CABINET MEMBER FOR ENVIRONMENT – 9 JANUARY 2014

PROPOSED TRAFFIC CALMING, TOWNSEND ROAD & STATION ROAD, SHRIVENHAM

Report by Deputy Director for Environment & Economy (Commercial)

Background papers: Annex 1: Plan

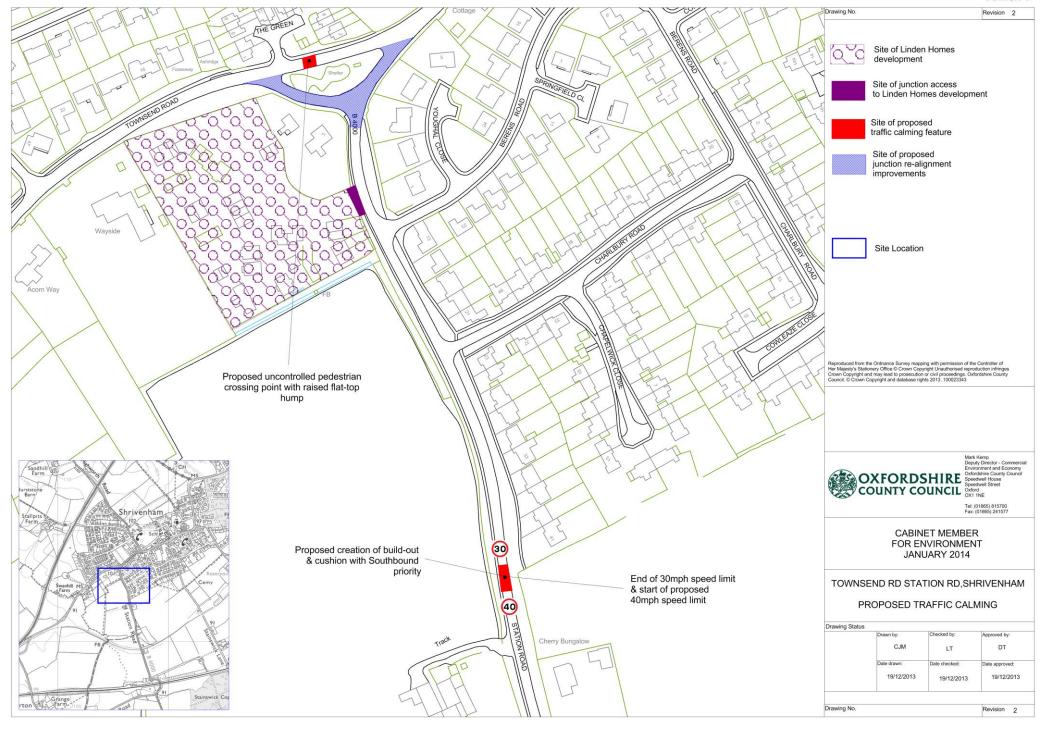
RESPONDENT	OBJECTION/COMMENT	OFFICER RESPONSE
Thames Valley Police	Make no objection.	Thank you.
Stagecoach in Swindon	Have no problem from their point of view.	Thank you.
Shrivenham Resident	The 'flat top' road hump on Townsend Road will not encourage 4x4 and commercial vehicles to slow down, since their suspension will take the hump without noticing.	Townsend Road is a premium bus route. This traffic feature is a compromise between lessening discomfort for bus occupants whilst still providing some degree of calming where pedestrians are directed to cross the road.
	The speed cushion on Station Road is too far south of the junction, encouraging 4x4, commercial and heavy farm vehicles to accelerate heavily to the main junction.	Initial consultation response indicated that in general Station Road residents were not in favour of a series of speed cushions along the road.
		Introduction of a new 40 MPH buffer speed limit south of the existing 30 MPH built up area, the requirement to negotiate the speed cushion, and the potential of having to give way to oncoming traffic at the build-out should slow northbound vehicles.

Shrivenham Resident	Strongly disagrees with construction of a build-out and speed cushion on Station Road. Accepts the need for a traffic calming measure and suggests that a 'flat top' road hump similar to that proposed for Townsend Road would be sufficient.	There is a proven speeding issue on Station Road within the 30 MPH built up area. Construction of a build-out and speed cushion where vehicles will have to negotiate both horizontal & vertical features (and in the case of northbound vehicles potentially have to stop) is likely to be more effective than a 'flat top' road hump.

Speed cushions are notorious for damaging car suspensions & tracking even when negotiating them with due diligence. Precedence is already set in at least two areas of Swindon where they have been removed.	Following initial consultation the number of speed cushions has been reduced to one. The chosen narrower / lower profile of this speed cushion (75mm high, 1.7m wide) should not cause damage to vehicles provided that drivers negotiate the feature at an appropriate speed.
Cleycourt Road, Shrivenham Resident	Speaking from experience having visited the Swindon area since the early 1980s speed cushions are dangerous to health and extremely painful. Needed surgery on a spinal complaint that was not caused by speed cushions but certainly not helped by them. At times the jarring of my back was very uncomfortable & on numerous occasions extremely painful.	Following initial consultation the number of speed cushions has been reduced to one. The chosen narrower / lower profile of this speed cushion (75mm high, 1.7m wide) should lessen discomfort to vehicle occupants provided that the driver negotiates the feature at an appropriate speed.

Youghal Close, Shrivenham Resident	Questions whether the one build-out & speed cushion on Station Road is sufficient to ensure reduced traffic speeds on approach to the new development's access. Submits that the County Council should consider re-instating the speed cushion on Station Road, just before Berens Road as indicated on the February plan as this would discourage traffic from accelerating along this stretch. Thinks there might be a case for re-	Initial consultation response indicated that in general Station Road residents were not in favour of a series of speed cushions along the road. Introduction of a new 40 MPH buffer speed limit south of the existing 30 MPH built up area, the requirement to negotiate the speed cushion, and the potential of having to give way to oncoming traffic at the build-out should slow northbound traffic. Re-alignment of the Townsend Road / Station Road junction should slow southbound traffic. Initial consultation indicated a consensus that the number of
